## Proposal for Supplement [x] to UN Regulation No. 148 (Light-Signalling Devices)

Annex 3, Par. 3.2., Figure A3-X, amend to read:

Figure A3-X

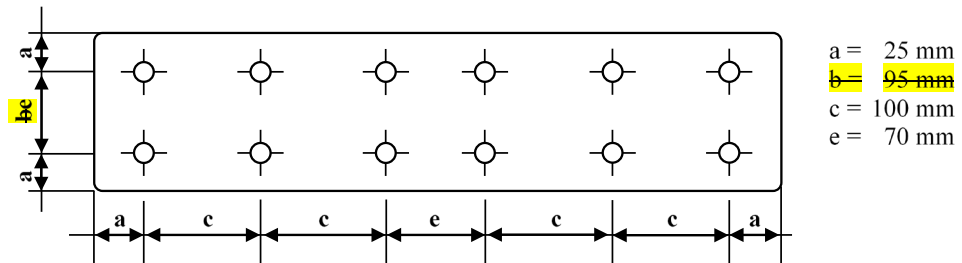
1. In the original version of Regulation No. 148 (WP.29/2018/157) the figure in Annex II, A3-X contains a mistake in the figure itself.
2. This proposal fixes the figure and reinstalls the original figure coming from UN Regulation No. 4, Annex 3 (b).

“3.2. Category 1b - wide plate (520 x 120 mm)
